Access Compliance Report

(Curb Ramps)

Intersection ID: 6011	Main Street: UNIVERSITY_CITY_BV	Cross Street: MARK_TWAIN_RD	Location: SE
ADA ID: 1DD2981046D8	Ramp Type: Perp	Initial Pass/Fail: Fail	Overall Compliance: No
Severity Score: 37.5			
Codes/Mitigation Info/Possible Solution		Field Measurements/Component Compliance

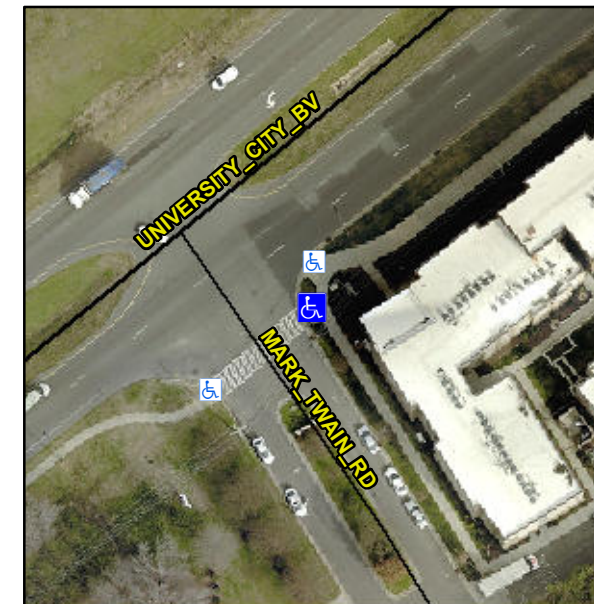
Not Found, R304.2.2, R304.5.3

Compliance	Description	Data	Compliance	Description	Data
N/A	Ramp Length (in)	99.0	No	Ramp Slope (%)	9.1
Yes	Ramp Width (in)	118.0	No	Ramp XSlope (%)	7.3
N/A	Flare Type LT	N/A	N/A	Flare Type RT	N/A
N/A	Flare Slope LT (%)	N/A	N/A	Flare Slope RT (%)	N/A
N/A	Flare Traversable LT?	N/A	N/A	Flare Traversable RT?	N/A
N/A	Landing Length (in)	N/A	N/A	DWS Provided?	N/A
N/A	Landing Width (in)	N/A	N/A	DWS Contrast?	N/A
N/A	Landing Slope (%)	N/A	N/A	DWS Length (in)	N/A
N/A	Landing X Slope (%)	N/A	N/A	DWS Full Width?	N/A
N/A	Landing Curb? (Y/N)	N/A	N/A	DWS Offset (in)	N/A
N/A	Shared Landing?	N/A			
N/A	Gutter Ponding?	N/A	N/A	Gutter Slope (%)	N/A
N/A	Gutter Lip Ht (in)	N/A	N/A	Gutter X Slope (%)	N/A
N/A	Painted X Walk1?	Yes	N/A	Painted X Walk2?	N/A
	X Walk 1 Direction	To SW		X Walk 2 Direction	N/A
N/A	X Walk 1 Width (in)	122.0	N/A	X Walk 2 Width (in)	N/A
	X Walk 1 Slope (%)	2.0		X Walk 2 Slope (%)	N/A
	X Walk 1 X Slope (%)	4.1		X Walk 2 X Slope (%)	N/A

Remove & Replace Entire Ramp.
